**Car Stereo  
Service Bulletin**

**Model:** CDX-U8000

**No. 260**

**Subject:** Does Not Retain Last Volume Setting

MAIN BOARD  
(CONDUCTOR SIDE)

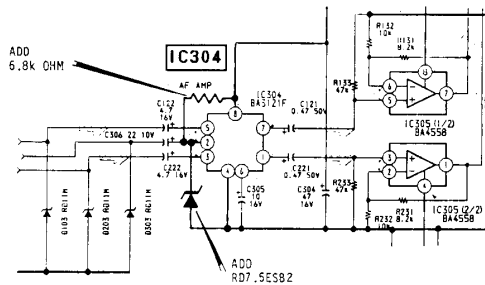
When the unit is turned on, it may not operate at the same volume level it was operating at when it was turned off. Pressing the VOLUME + or VOLUME - button once will restore the volume level.

Add the following components to the Walkman Input Amplifier Circuit:

DESCRIPTION	PART NUMBER
DIODE, ZENER RD7.5ESB2	8-719-110-03
RESISTOR, METAL CHIP 6.8K	1-216-069-00
